MCD

Object: Modifications N° 1 « locking striker modifications ».

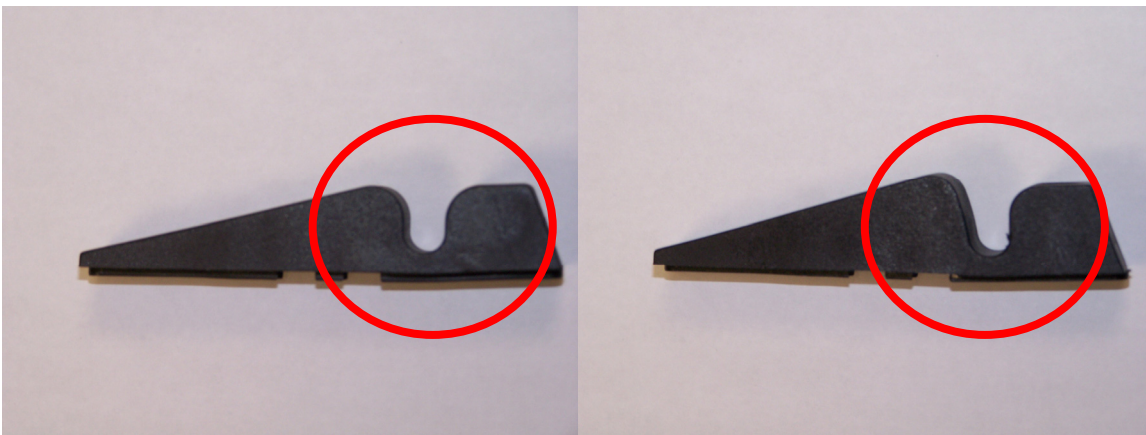
In fact, some MCD's users spoke about the difficulty they have to open shutters with double handle. They must constrict the bottom seal to open without difficulty their shutters.

We identify the problem and do the modifications: We have changed the opening radius and the depth on the locking striker creating a new mould. (*cf. Picture number 1 and 2*)
